Re: Minor Permit Modification
International Paper, Riegelwood, N.C. Permit 24-02

Figure A. Cell 1 South Expansion

International Paper, Rigelwood NC Culvert Analysis

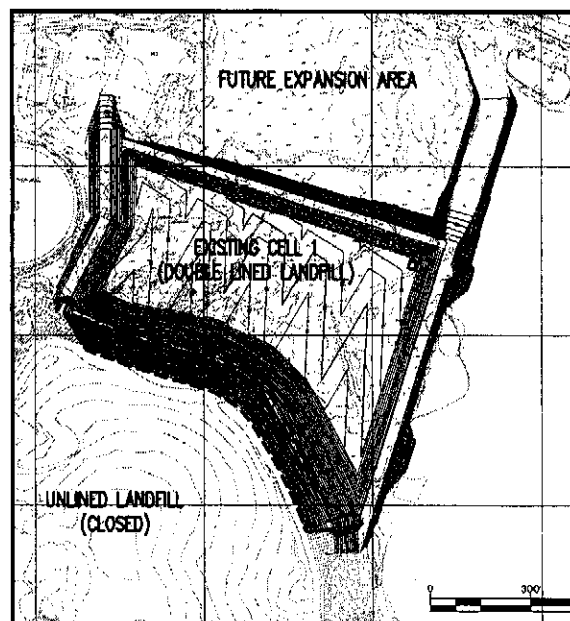
When Cell 1 was constructed, the southern limit of the liner system was approximately halfway up the soil berm of the unlined landfill. The proposed modification to Cell 1 will extend the liner system up the berm slope approximately 100-feet wide and 1,000-feet long that lies between Cell 1 and the unlined landfill, as shown on Figure A, below an in full detail on the drawings included with this submittal.

1. **Liner Extension.** The lined area of Cell 1 will be extended to the south by approximately 2.23 acres, as shown on Figure A. The expansion is made by covering the southern slope (which is the northern slope of the perimeter berm of the unlined landfill). The liner system will be extended up the 3H:1V slope to approximately elevation 85 (MSL), up from the existing elevation that varies from EL 55 to EL 66. The liner extension will bring the liner up to the top of the berm of the unlined landfill, as was the original intent of the design. The plans, details, and cross-section views of the expansion are presented on the attached drawings.

2. **Eliminate the double liner in the South Expansion.** Cell 1 was constructed with a leak detection layer underneath the primary liner system. However, in this proposed cell expansion area, the base grades are constructed of slightly clayey sand fill soil brought in from off-site. The entire liner system of the Cell 1 South Expansion is on a 3H:1V slope, so there is little chance for any head to build up over the liner, meaning little chance of a leak. Additionally, the underdrain system at the toe of the slope (underneath the leak detection layer) would collect any leak that might occur and return it to the wastewater treatment system. Therefore, no secondary liner system is proposed for under the expansion area, and only the primary liner system will be installed.

IP Riegelwood
 Landfill Culvert
 Culvert C-1

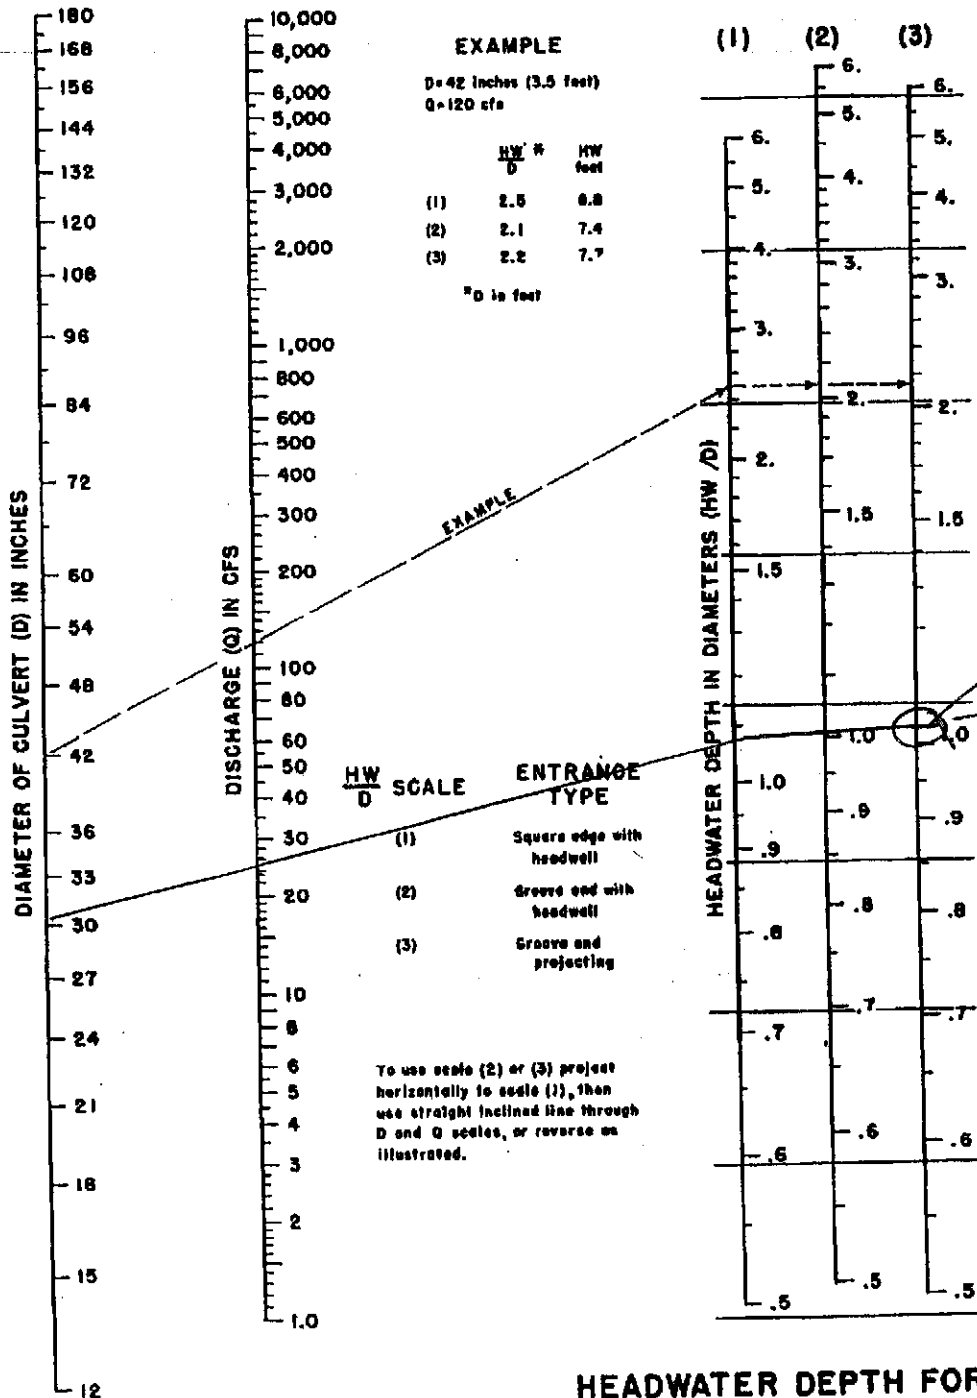
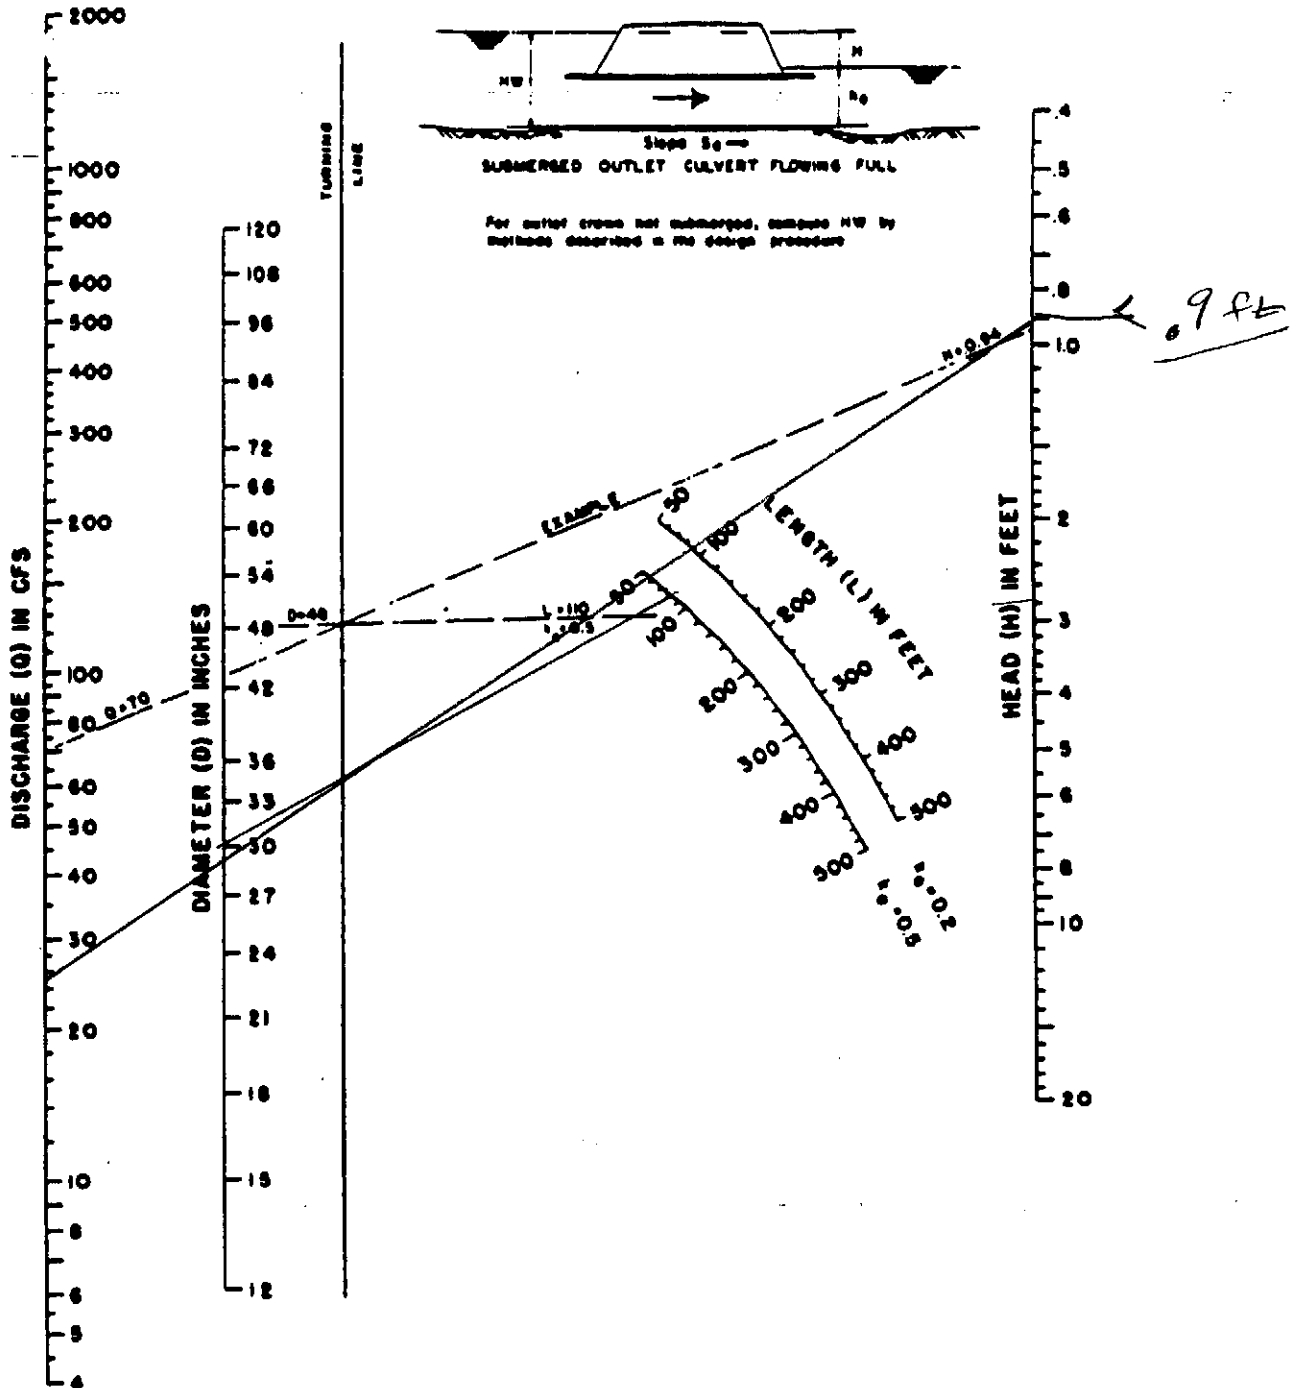
Q=25 CFS
MAX

$$Q_{max} = 25 \text{ CFS}$$

Culvert C-1
Drainage Area

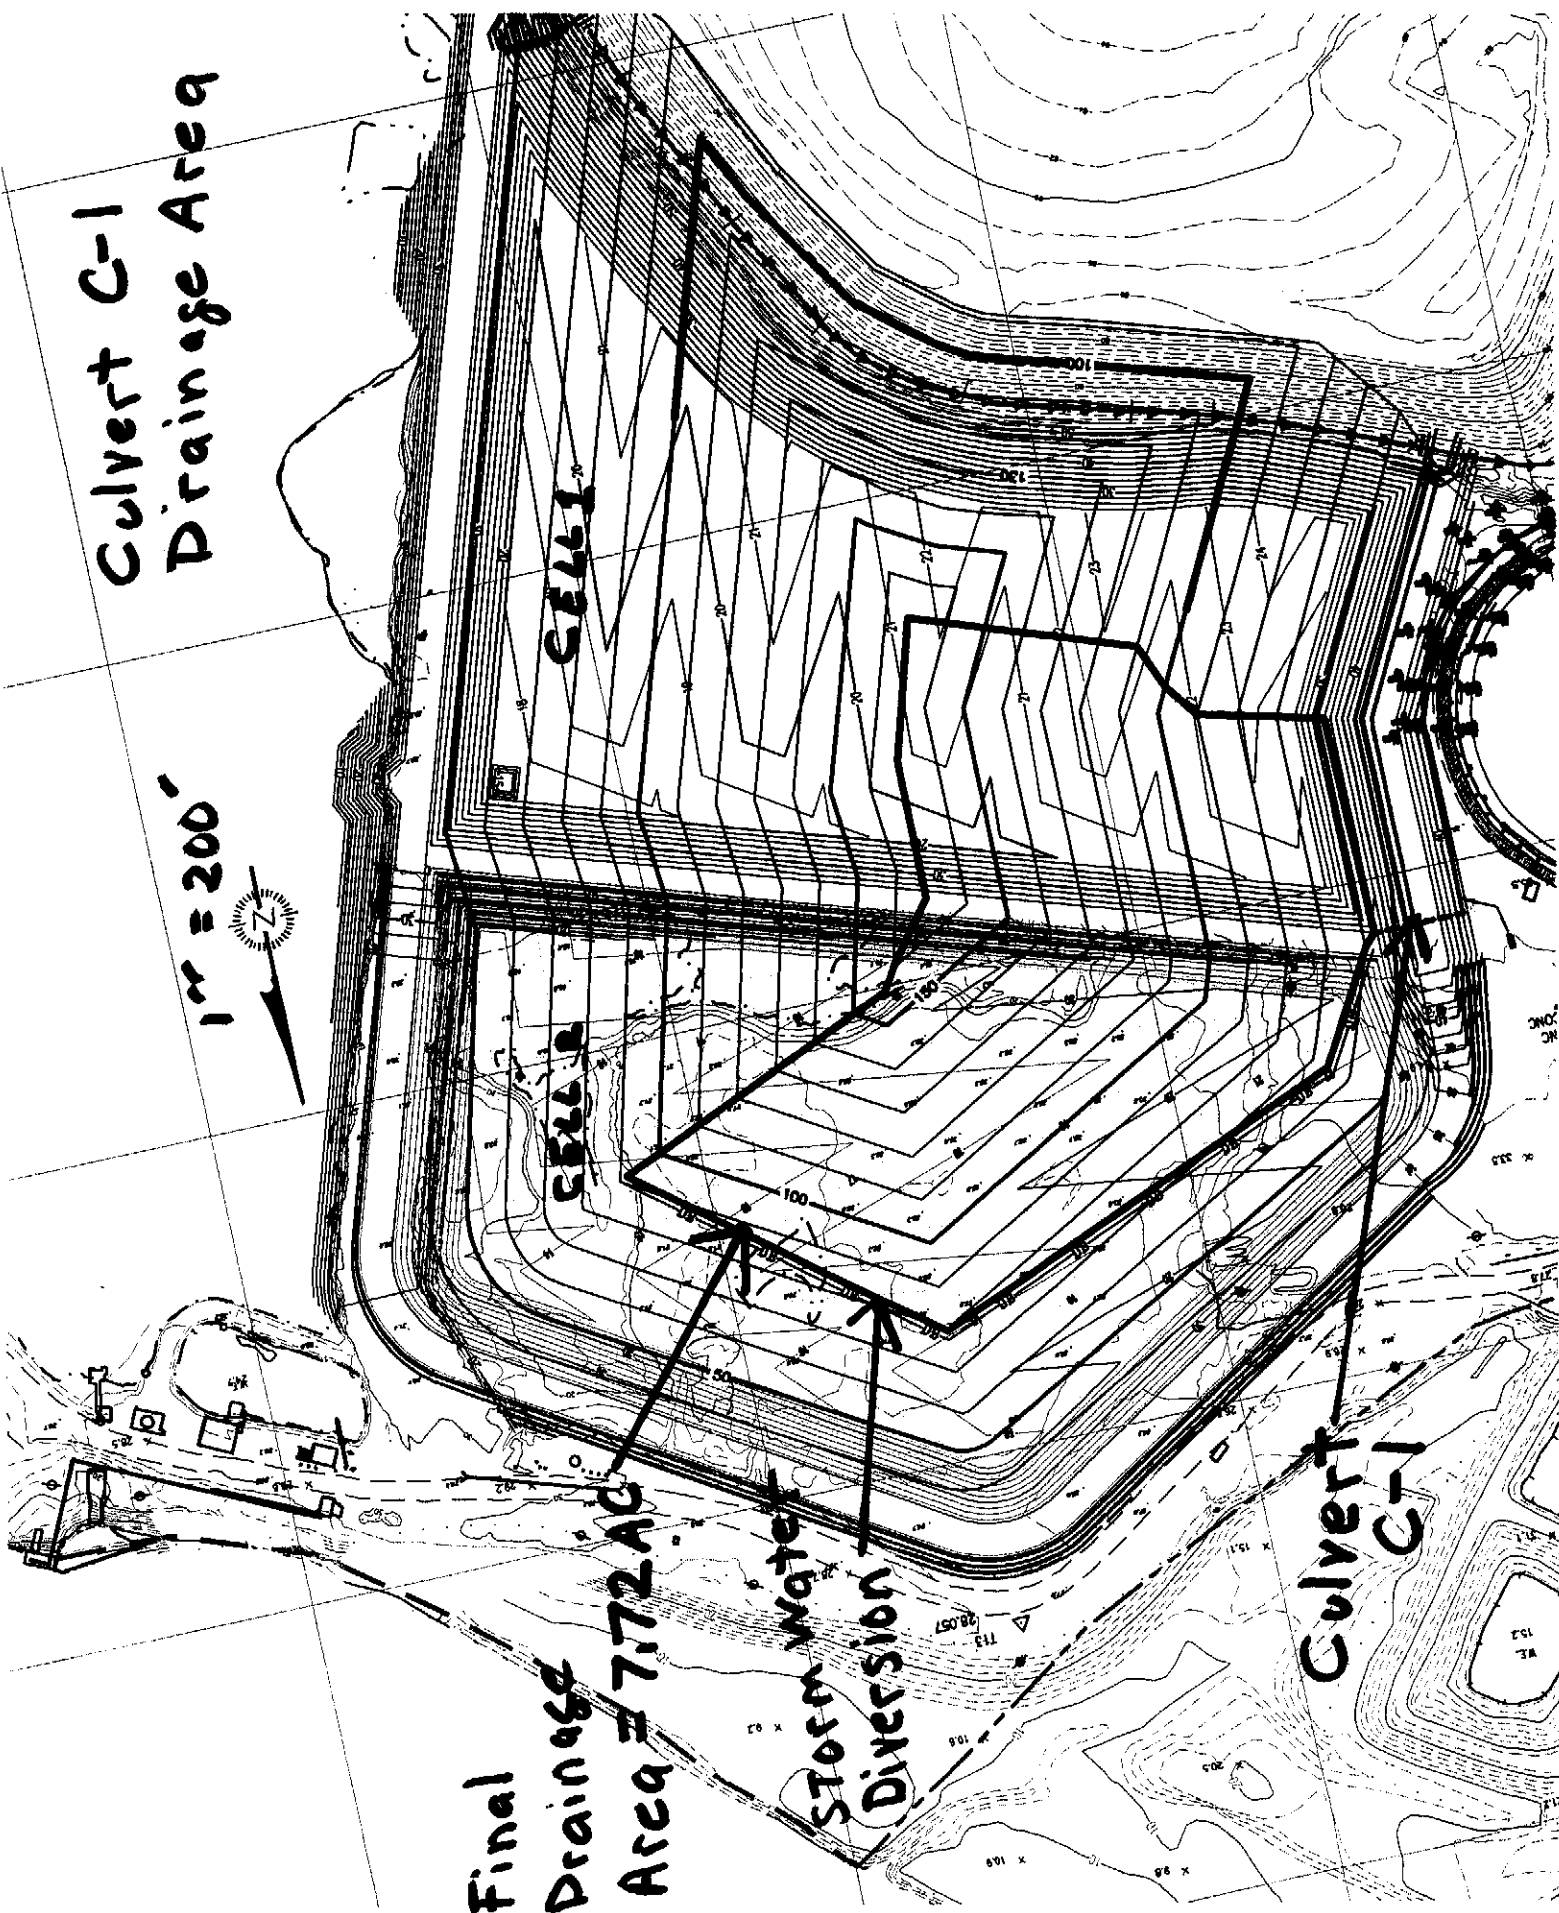
CONCLUSION: A SINGLE 30 INCH PIPE IS ADEQUATE FOR CULVERT C-1 (AT THE DIVIDING BERM B/TW CELL 1 AND CELL 2)

Final
Drainage
Area = 7.72 AC

Drainage Area = 9.25 A

IP Riegelwood
Culvert C-2

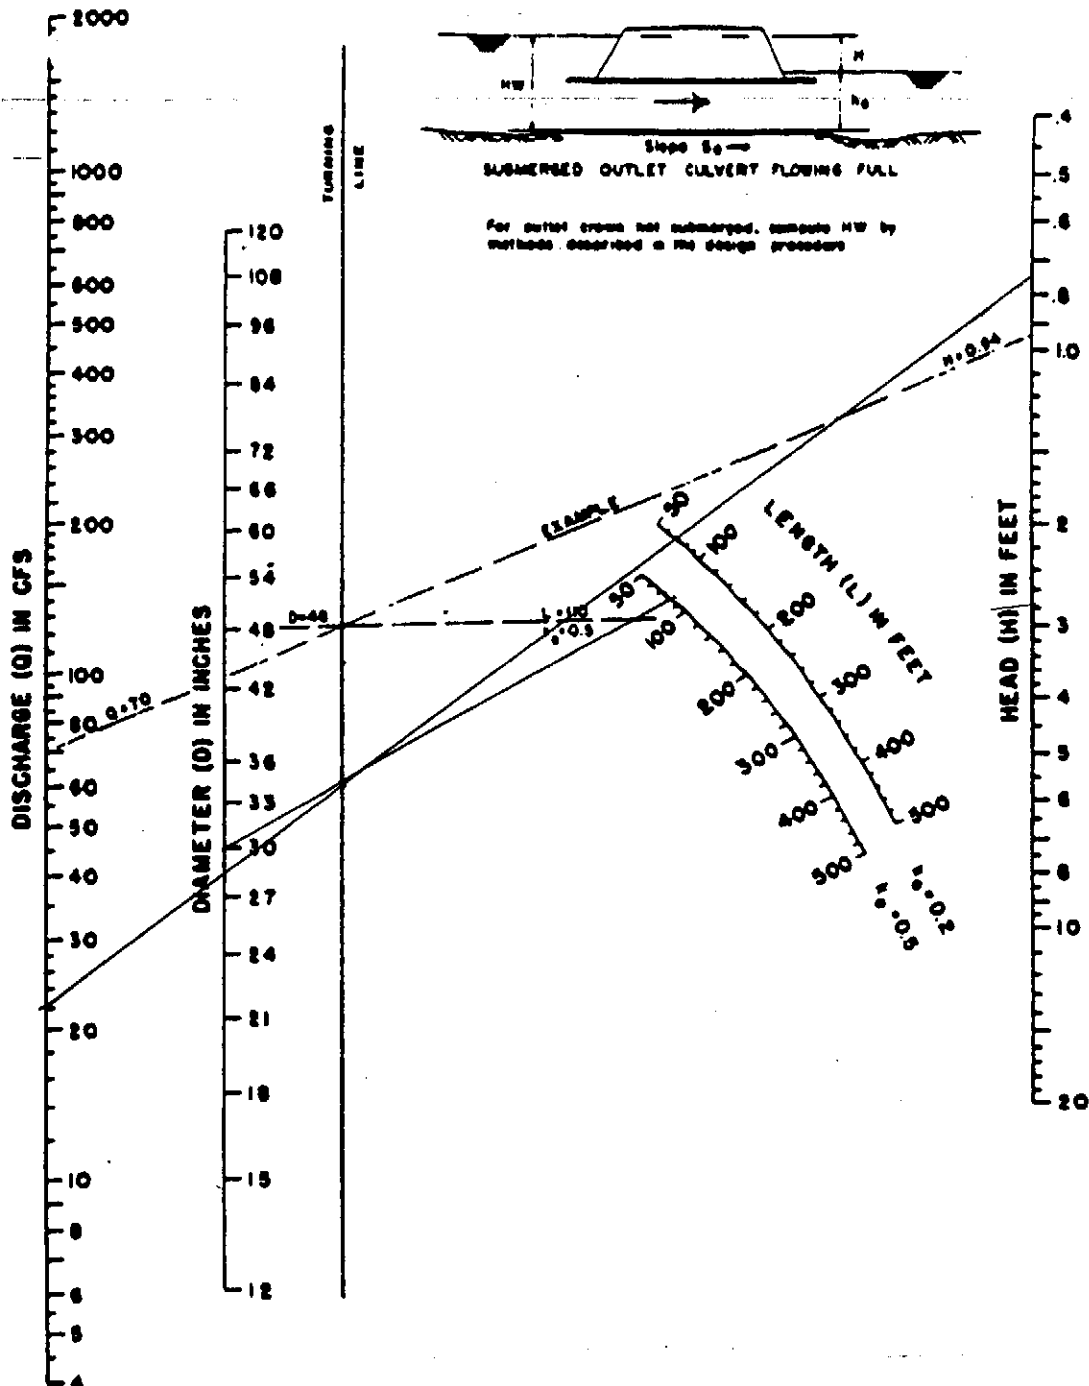
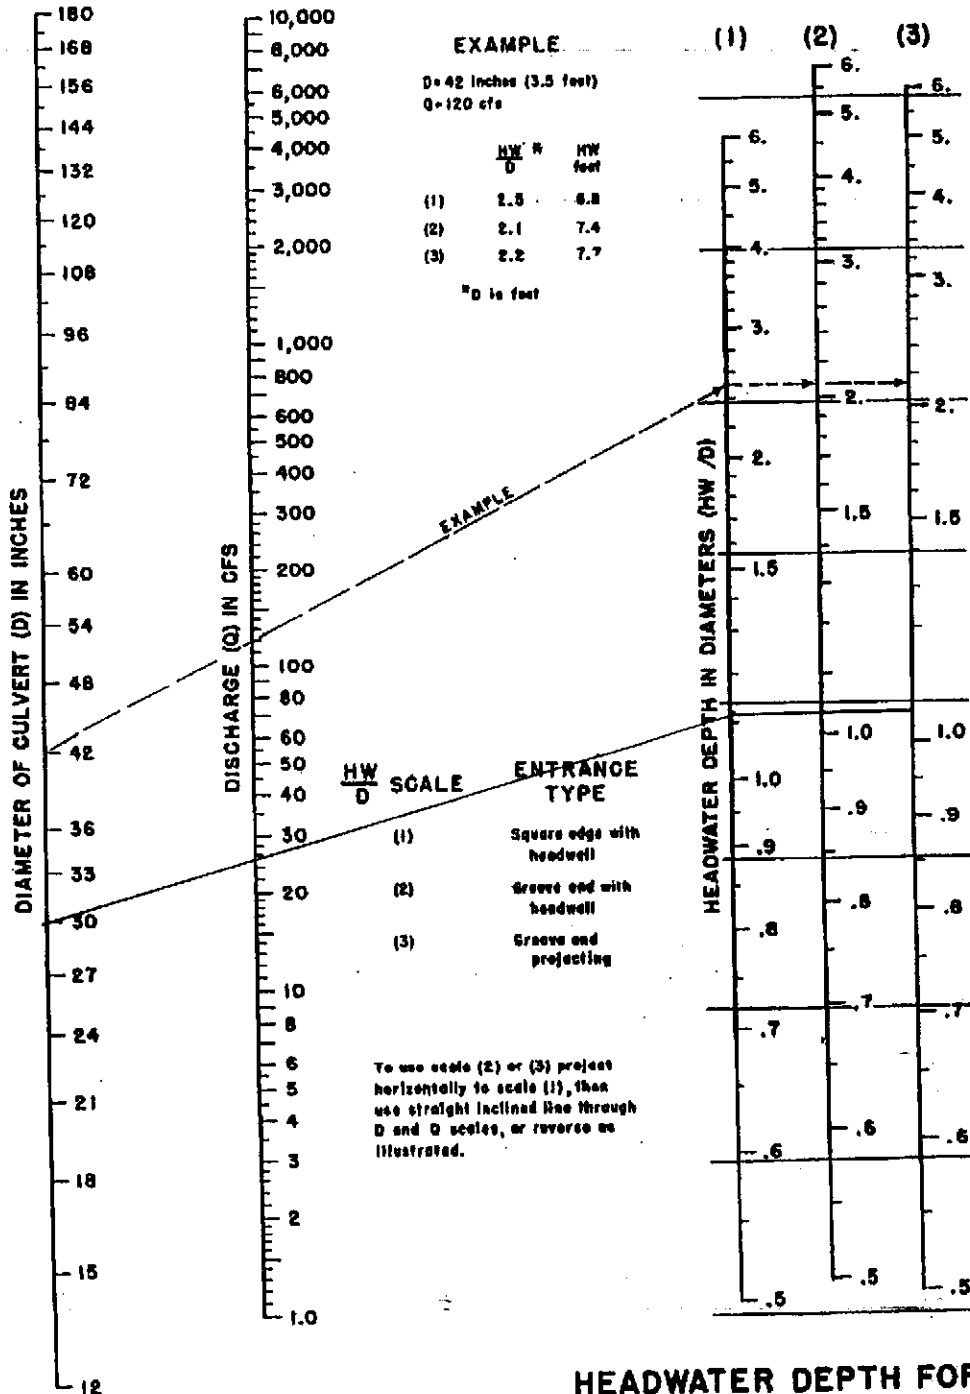
CONCLUSION: A SINGLE 30 INCH PIPE IS ADEQUATE FOR CULVERT C-2 (at the end of the bench)
